**BEFORE THE PUBLIC SERVICE COMMISSION
OF THE STATE OF MISSOURI**

STAFF’S UPDATED REPORT AND MOTION FOR EVIDENTIARY HEARING

PICTURE REPORT

INSPECTION REPORT

PENGAD 800-631-6888
EXHIBIT
14
12/6/07 mw

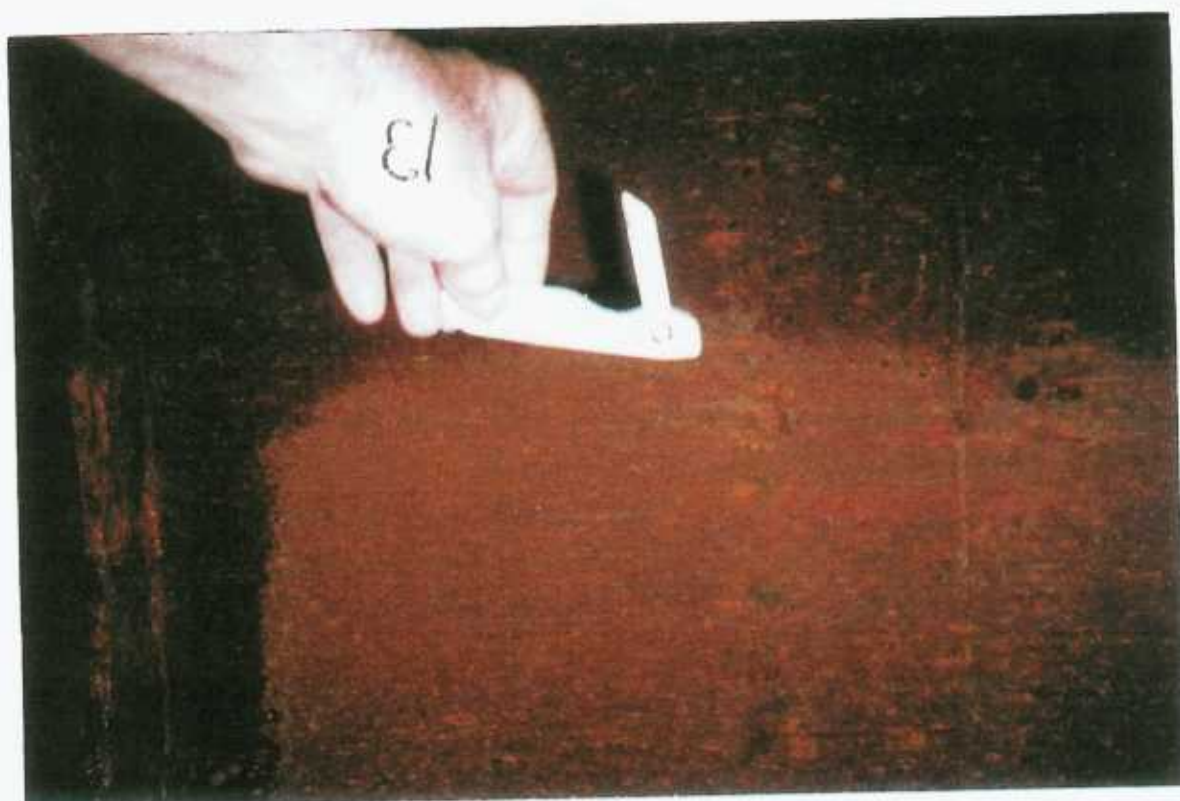
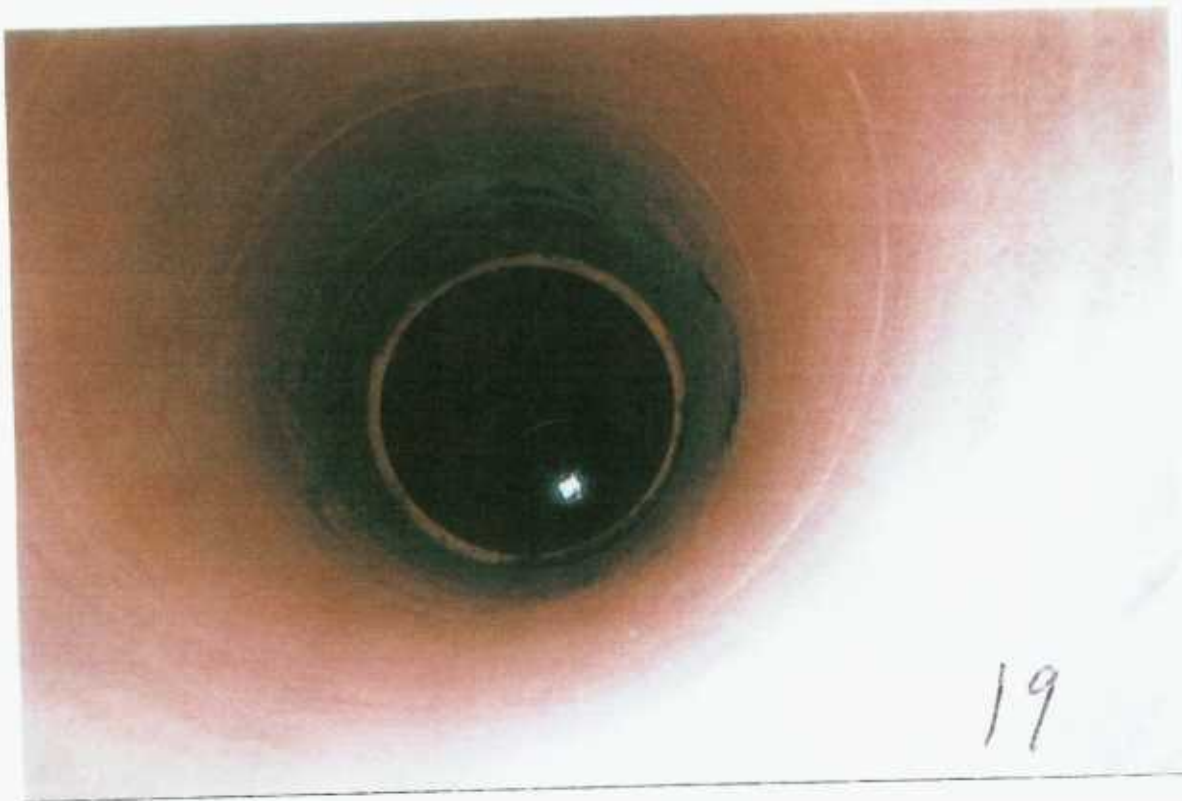
1. The standpipe has **no coating** between the wall of the tank and the water that is distributed to Suburban's water customers. Customers are consuming water that is in direct contact with rust, blisters, pits and barnacles inside the standpipe. The pictures attached to Zelch's deposition as Exhibit 14 show in numbers 8 through 19 that the inside of the tank, as described by Zelch in Exhibit 15, is "SOLID RUST", "RUST, RUST and more RUST" and "NO paint, just rust"(emphasis in original). Deposition Exhibits 14, 15, and 16 are attached hereto.

2. Zelch states that picture number 15 shows "heavy barnacles, blisters and pits. **I am confident that if I scratched very much, I would find pits that go completely through to daylight**"(emphasis in original). Describing picture number 17, Zelch claims "the lower $\frac{1}{4}$ to $\frac{1}{3}$ of the tank is ABSOLUTE JUNK AND NOT REPAIRABLE. The tank will have to be replaced, it is not worth spending money on this one." Zelch Depo. Exhibit 15. Zelch identified over 30 patched leaks on the tank. Zelch Depo., p. 41.
